Re: FirstLight Hydro Generating Company, Turners Falls Hydroelectric Project (FERC No. 1889) and Northfield Mountain Pumped Storage Project (FERC No. 2485).
Response to Comments

Study No. 3.3.1 Instream Flow Studies in Bypass Channel and below Cabot Station

Northfield Mountain Pumped Storage Project (No. 2485) and Turners Falls Hydroelectric Project (No. 1889)
Study Reports Comments and Responses

- Years 2000-2003
- Years 2004-2007
- Years 2008-2012
- Years 2013-2015

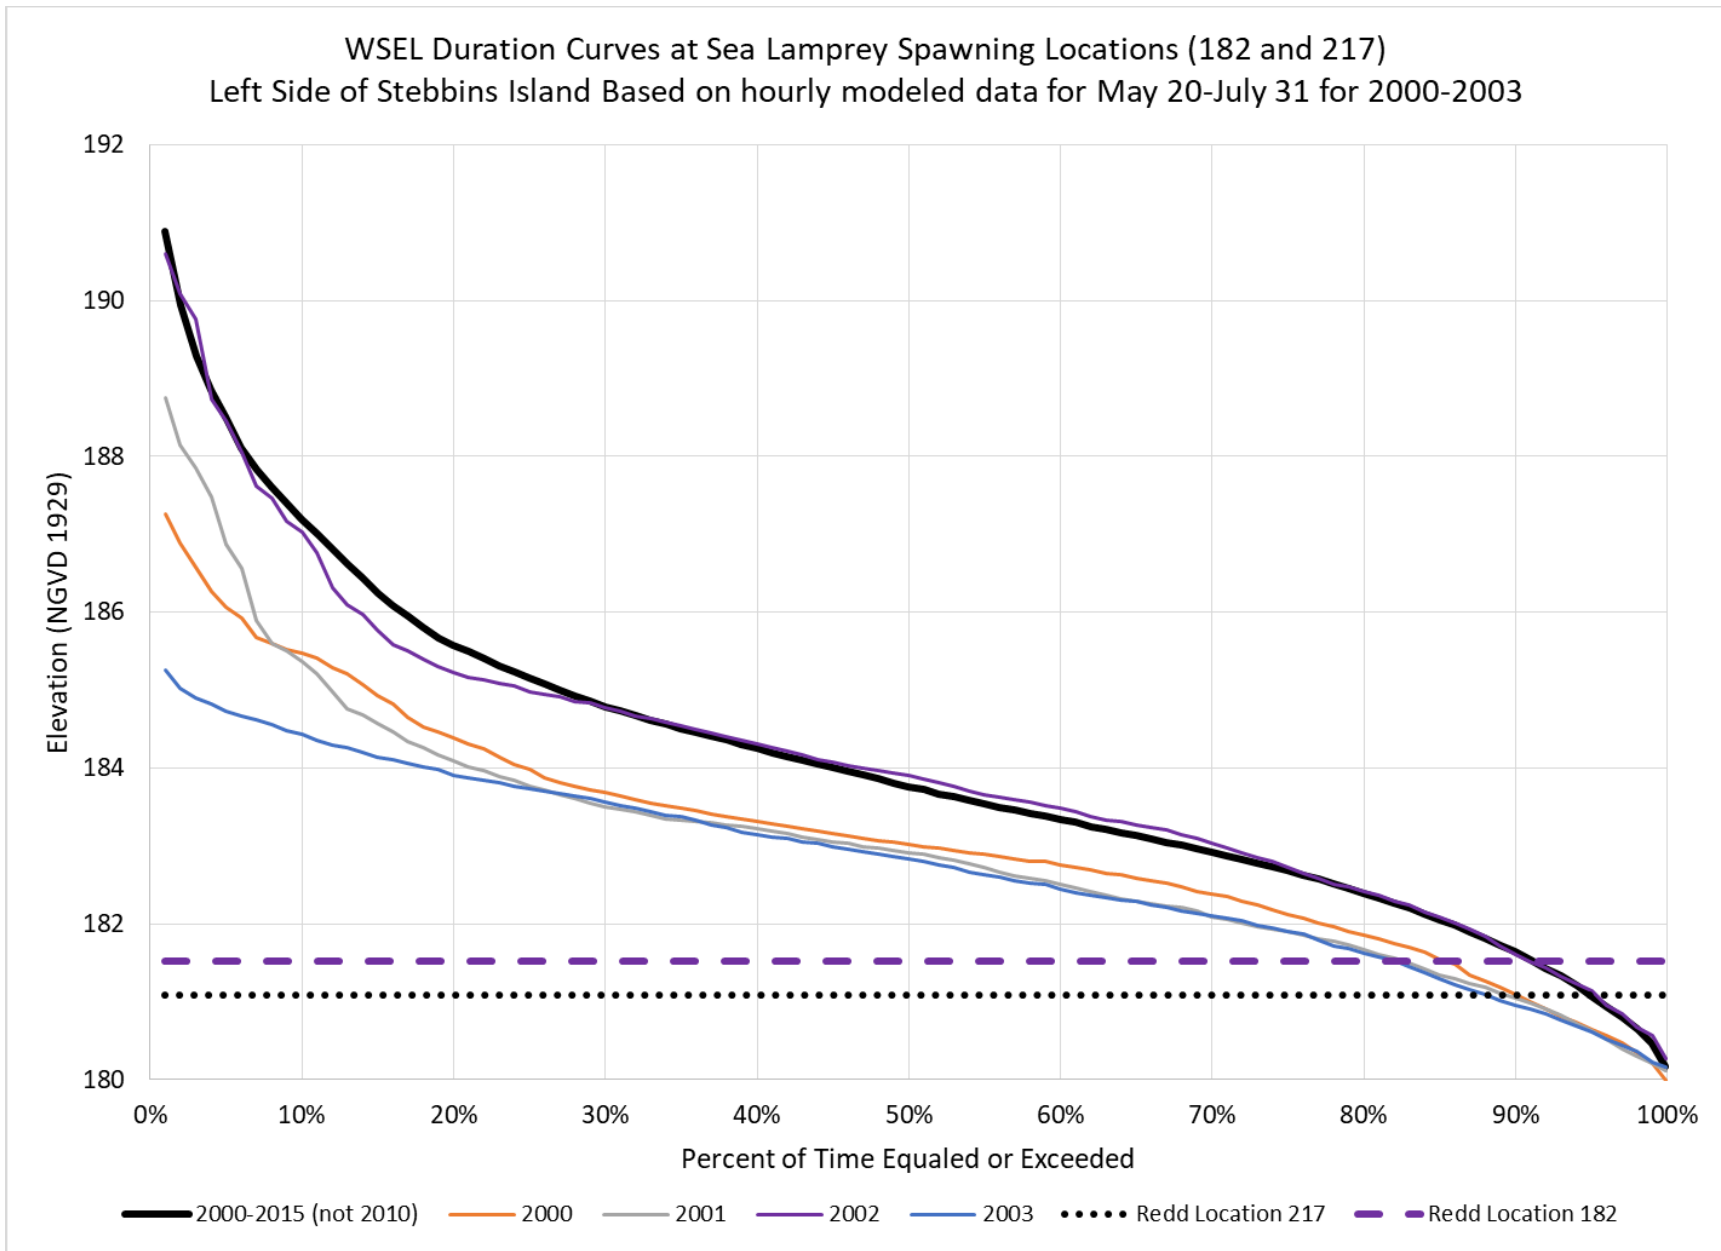
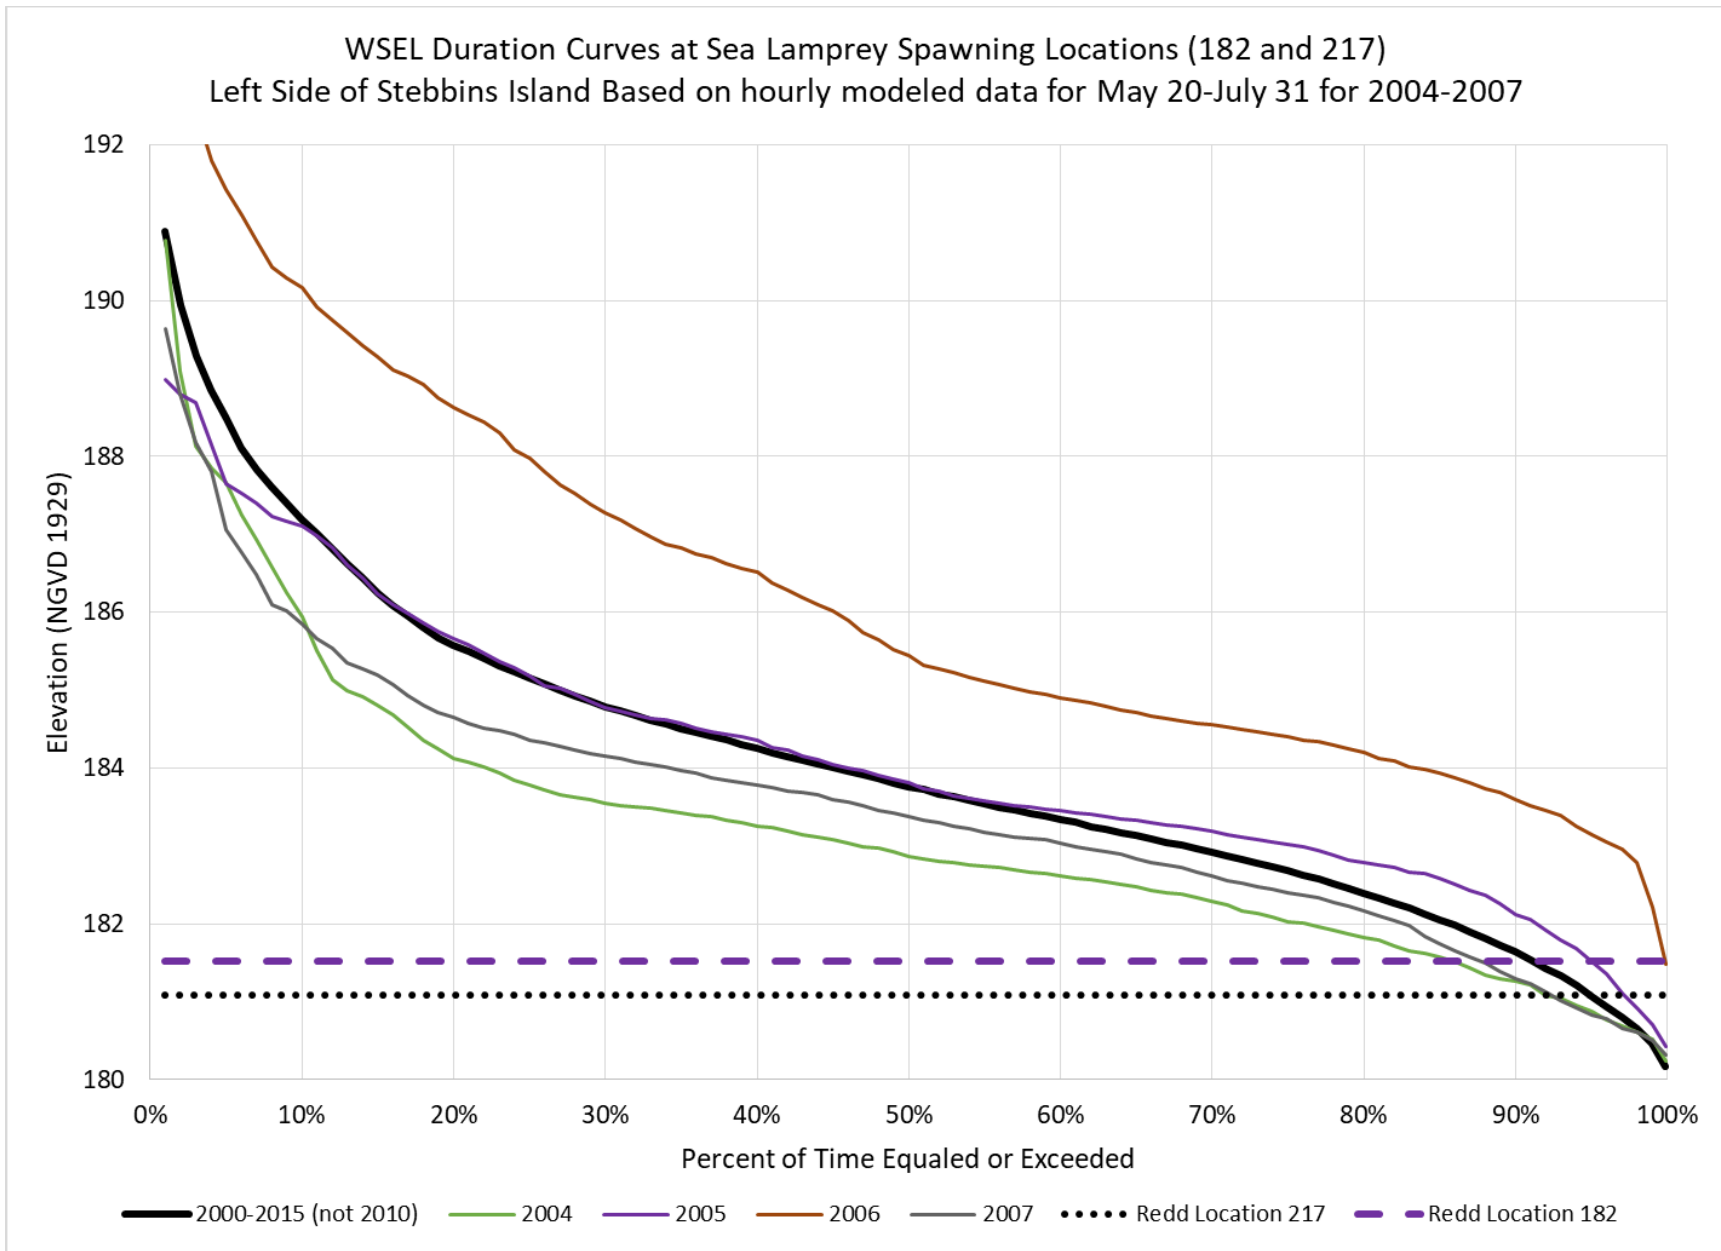
Commenter	Comment	Response
USFWS-1	<p><u>Re: Sea Lamprey Spawning Survey</u> Addendum 1 to this study focused on assessing inundation and exposure at the seven sea lamprey redd locations documented in the vicinity of Stebbins Island during the 2015 field surveys associated with Study 3.3.15. Redd bed channel elevations were compared to water surface elevations (WSELs) at the closest HEC-RAS transect to a particular redd and evaluated at an hourly time step for the period January 1,2000 through September 30,2015. For the three transects closest to the redds, hourly WSELs from May 20 to July 31 (the sea lamprey spawning period) were used to develop WSEL duration curves.</p> <p>Based on the analysis, two redds were dewatered approximately 11 to 14 percent of the time, two were dewatered 5 to 8 percent of the time, and three were dewatered about 1 to 2 percent of the time. According to FL, redd dewatering is a function of releases from the Vernon project (FERC No. 1904) as well as water surface elevations in the Turners Falls Impoundment (in addition to other variables).</p> <p><i>Comments & Recommendations:</i> Figures 2-2 (nests 219-1 and 219-2),2-3 (nests 182 and 217) and 2-4 (nests 220, 221,and 222) portray water surface elevation duration curves based on hourly modeled data for the period May 20 through July 31, with one curve representing 15 water years (2000 through 2015). In order to better understand how interannual variability may influence the amount of time WSELs are below the redd bed elevations, we request that FL revise each figure to have separate curves for each water year.</p>	<p>3.3.15 Attachment A includes elevation duration curves for nests 219-1 and 219-2, nests 182 and 217 and nests 220, 221, and 222 for individual years from 2000-2015 (excluding 2010 in which NFM was inactive). The water surface elevations are based on hourly hydraulic modeling.</p>

NMFS-1	<p><u>Re: Sea Lamprey Spawning Survey</u> FirstLight revise each figure to present separate curves for each water year to present the annual variability. Separating the annual data will better depict annual variability and the time WSELs are below the redd bed elevations. This output will help evaluate the potential affects that project operations have on sea lamprey spawning and productivity.</p>	<p>See USFWS-1.</p>

Attachment A: Weekly Total Densities by Lifestage for 2015 and 2016 (Figure 1 and 2)

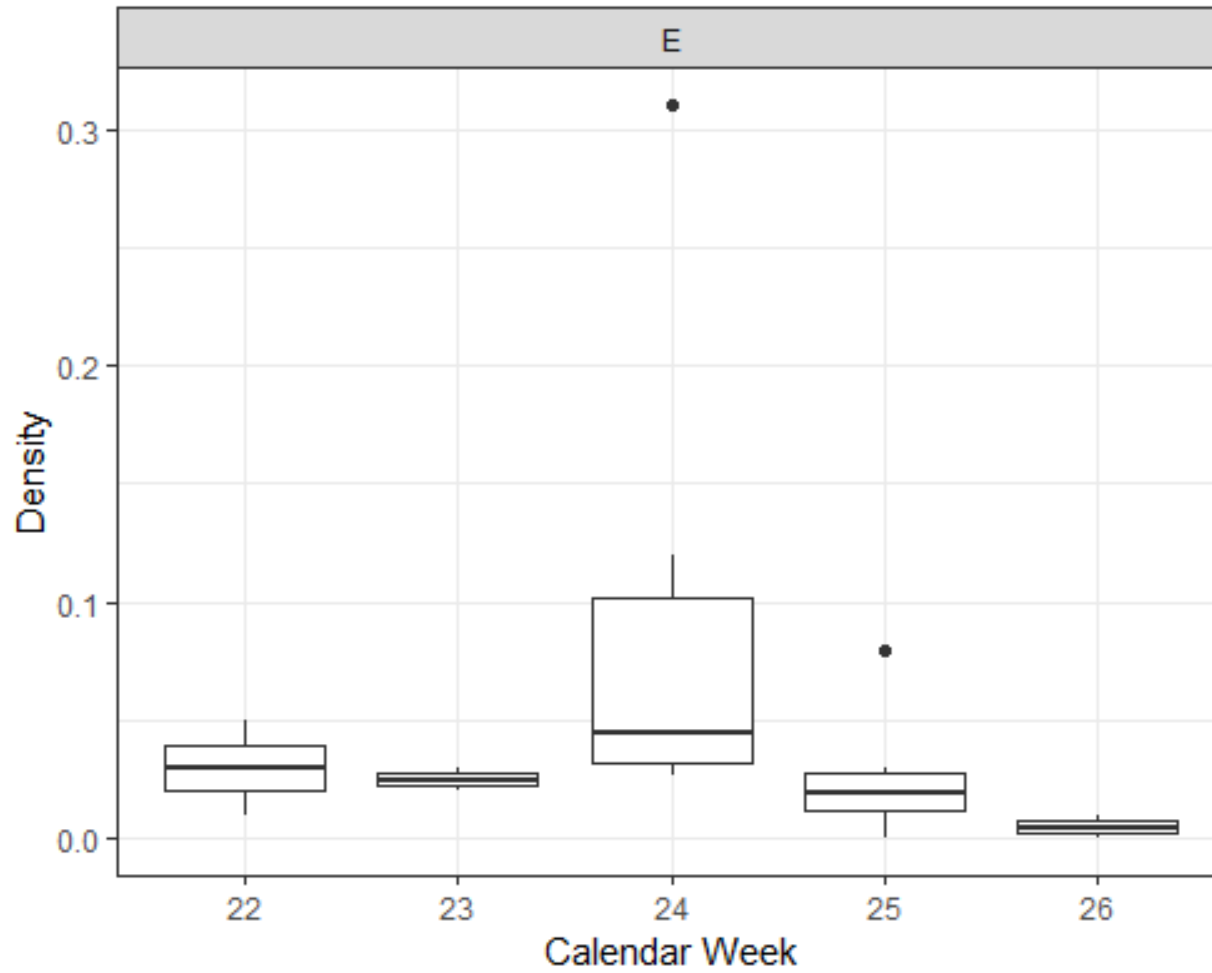
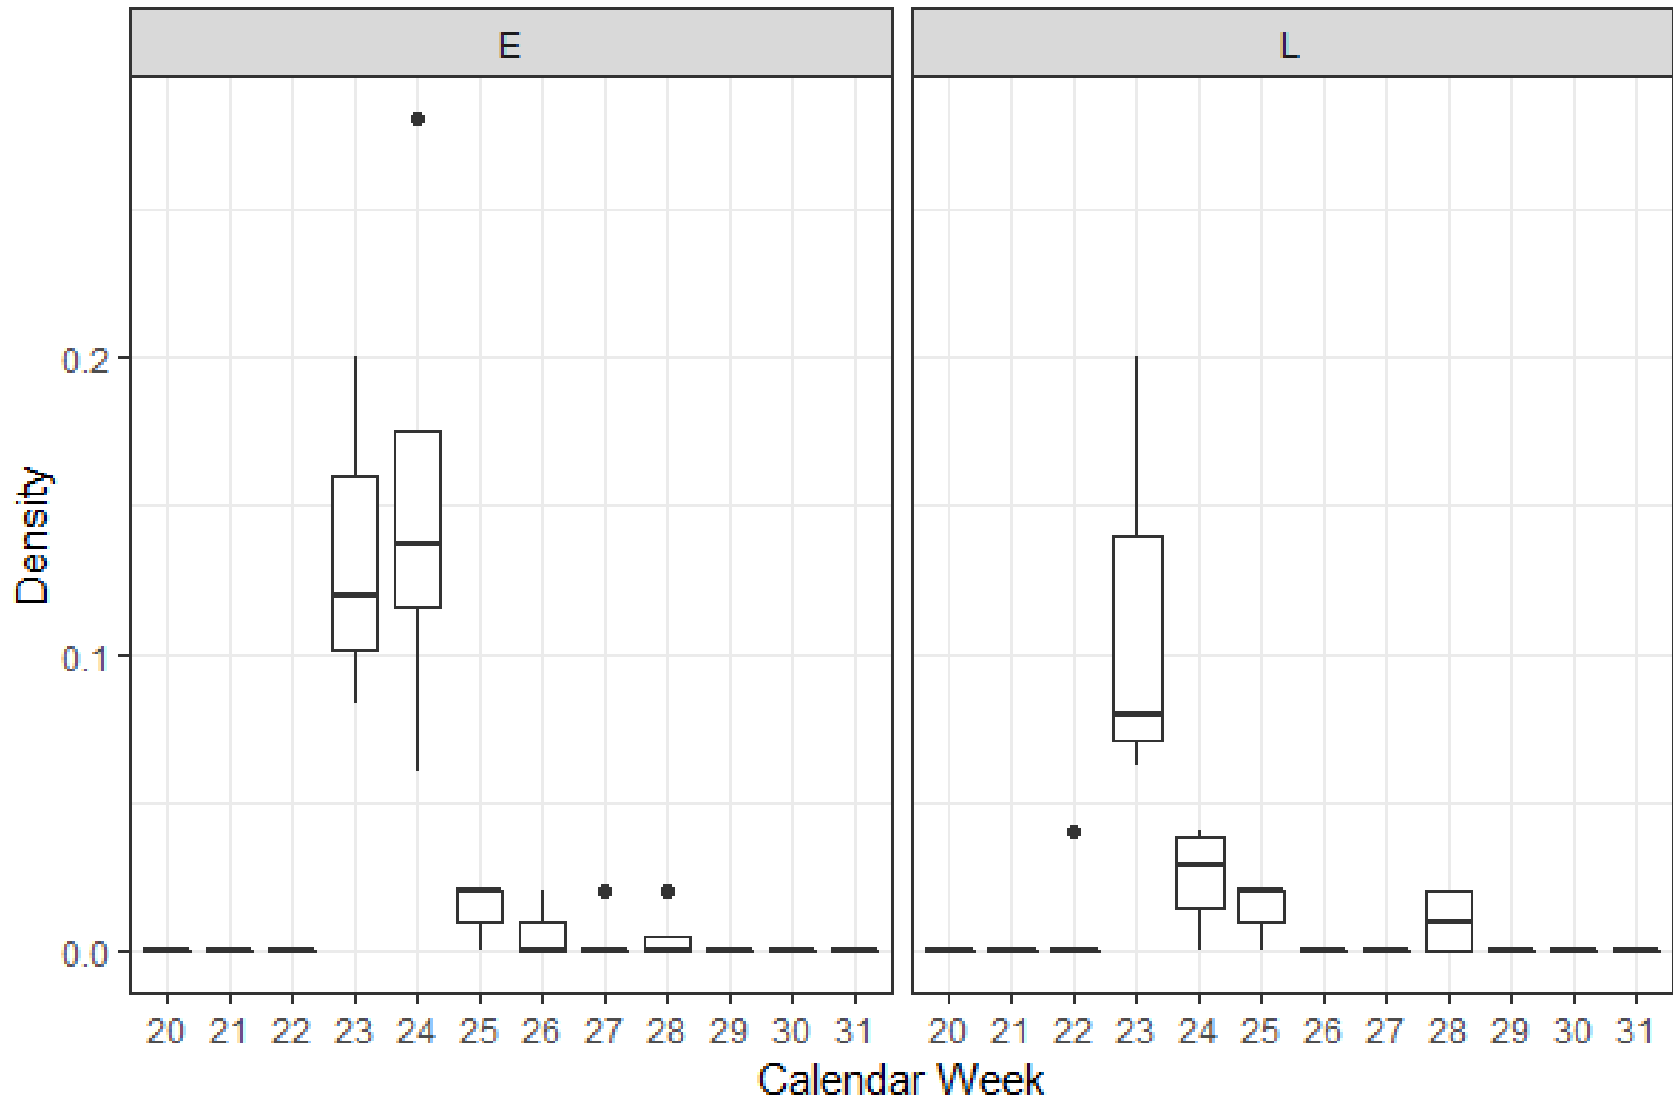
USFWS-2	FL states that water year 2002 was chosen because flows were generally lower than average relative to the recent period of record (1975 to 2015). Actually, when looking at the period of time when early life stages of American shad are in the River, 2002 falls within the normal range (Attachment A).	No Attachment A was provided in the filing. The comment does not include a request for more information
USFWS-3	It is unclear why FL chose only a single water year to model. In order to better understand the variability in entrainment potential under expanded operations, several water years should be modeled, representing a range of hydrologic conditions. In addition, no explanation is given for using operation personnel's professional judgement versus changing parameters (i.e., upper and lower Upper Reservoir elevation limits) within the operations model to assess how much more water would have been pumped under the expanded operations scenario.	The comment does not include a request for more information. However, relative to FL choosing a single year to model, FirstLight notes the following: The timing, magnitude and duration of water pumped to the Upper Reservoir are independent of the magnitude of water flowing by the Northfield tailrace. Pumping is driven by market conditions, irrespective of flow. Given this, FirstLight did not simulate multiple years. Regarding using operation personnel's professional judgement vs changing parameter in the operations model, the operations model was changed to allow the Upper Reservoir to operate over a wider band.
